CITY OF CODY
PLANNING, ZONING AND ADJUSTMENT BOARD
TUESDAY, APRIL 9, 2013
CITY HALL COUNCIL CHAMBERS @ 12:00 NOON

MEETING DATE:	APRIL 9, 2013	TYPE OF ACTION NEEDED	
AGENDA ITEM:		P&Z BOARD APPROVAL:	
SUBJECT:	BOYDSTON MINOR SUBDIVISION—A FIVE-LOT PRELIMINARY AND FINAL PLAT APPLICATION. SUB 2013-03	RECOMMENDATION TO COUNCIL:	X
PREPARED BY:	TODD STOWELL, CITY PLANNER	DISCUSSION ONLY:

Joseph Boydston, as property owner, has submitted a preliminary plat application and final plat application for a five-lot minor subdivision. The 4.84 acre property is located on the west side of Date Street, immediately south of Big Horn Avenue. The preliminary plat drawing showing the lot layout is attached.

PRELIMINARY PLAT

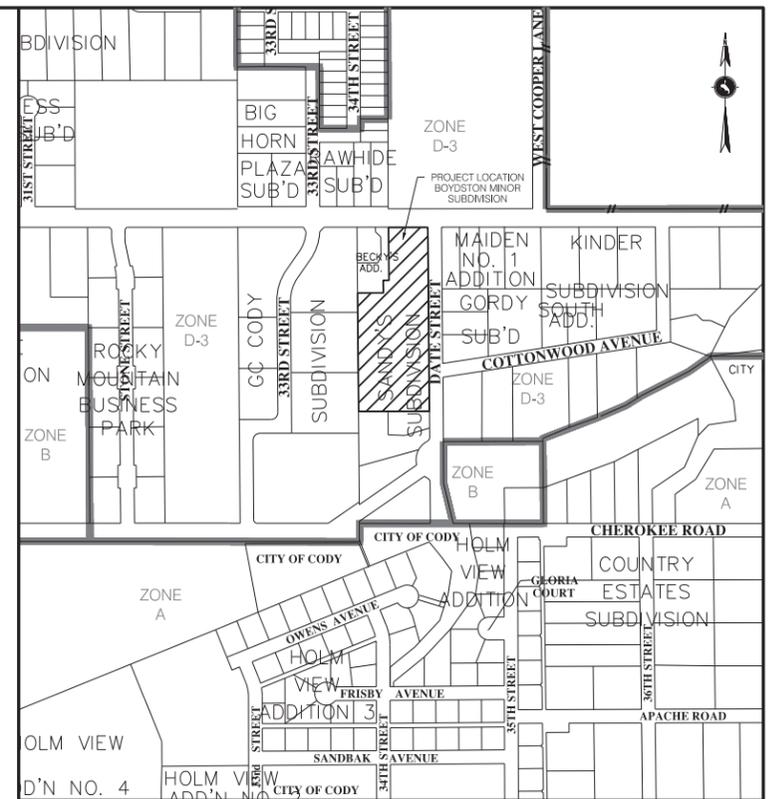
Staff Comment: Requirements 1 through 4 are met. It is noted that access for Lot 1 will be required to be from Date Street, rather than Big Horn Avenue (state access management requirements apply), and that the entrance from Date Street will need to be toward the south end of the lot at least 100 feet from Big Horn Avenue. It is recommended that a note be placed on the final plat to this effect.

Staff Comment: Irrigation ditches run along the west, south, and east property lines. The irrigation ditch along the west side of the property will remain, but the ditch that runs along the south property line and east portions of Lots 3, 4 and 5 will be abandoned, as the owner has filed for detachment of the water rights from the property.

Power. Electrical service is required to be modified so that the existing overhead lines do not cross the intervening lots. The new system will be underground. The City Electrical Engineer has provided a design and cost estimate for the modifications. The payment will need to be made prior to the final plat being signed by the mayor. A 10-foot easement along Date Street is needed for the electrical lines and transformers.

FINAL PLAT

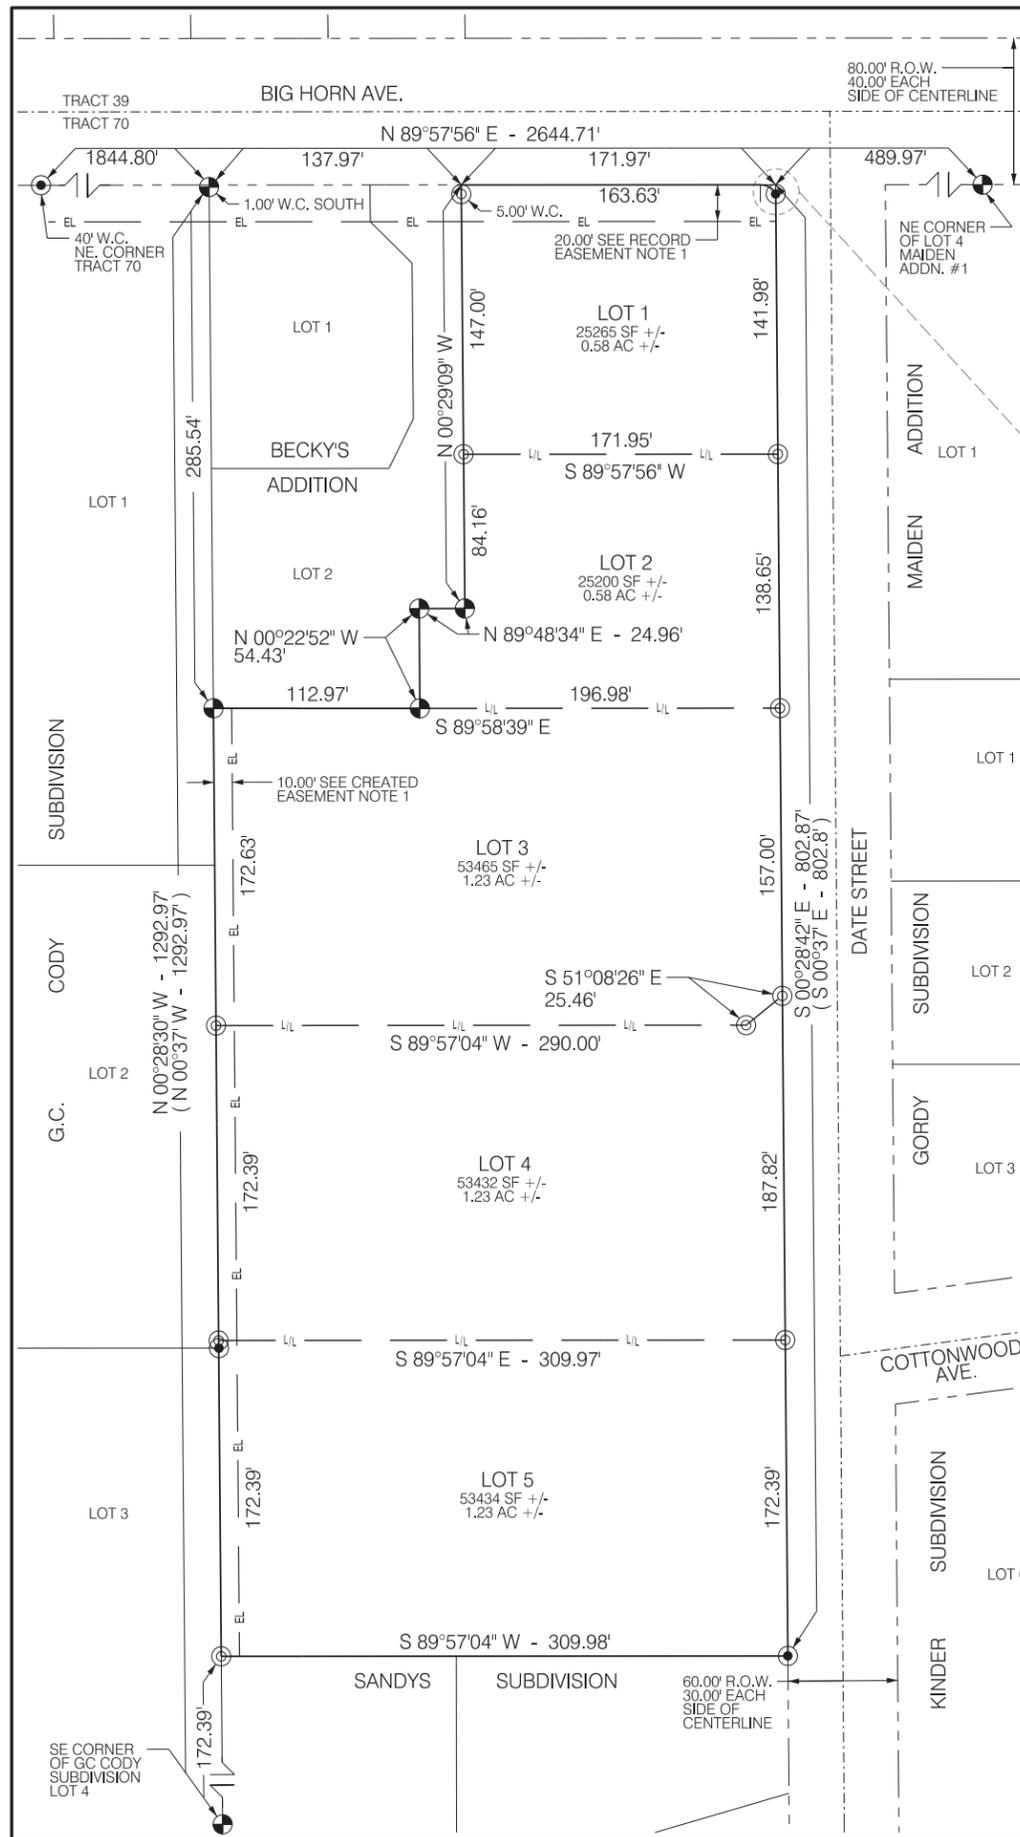
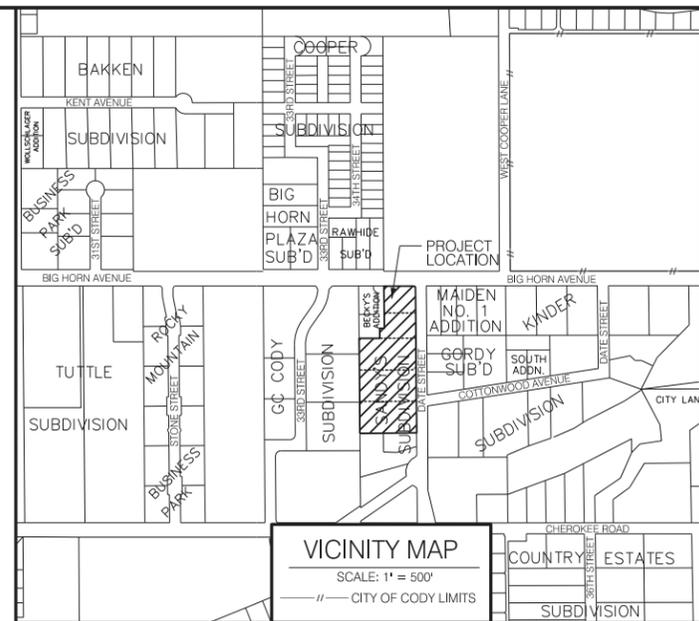
If a form of delayed improvement is decided on, it should be clearly noted on the final plat to help avoid a situation where a lot is sold and the purchaser is not fully aware of street improvement requirements. The option of phasing or waiving some of the street improvements, such as sidewalks and streetlights may be another factor to consider, (e.g. widen street now, put sidewalk in with development, etc.)

If construction in conjunction with individual lot development is the preferred method, the following note is recommended for the final plat.

- 3. Provide utility easements as required by the utility providers. At a minimum, provide a 10-foot utility easement along Date Street.
- 4. The language on the final plat for the irrigation easement must be expanded to indicate the property or entity to which the easement is granted.

10. Add the following note to the final plat: "Access for Lot 1 will be required to be from Date Street, rather than Big Horn Avenue, and the entrance from Date Street will

1. Utility comments – Letters from utility companies will be submitted prior to Final Plat approval by the City Council.
2. Power – Underground power will serve all lots within the subdivision.
3. Variances – Variance requests are detailed in the enclosed letter.
4. Water Rights – All water rights for this property have been detached.
5. Typos on the plat have been addressed.
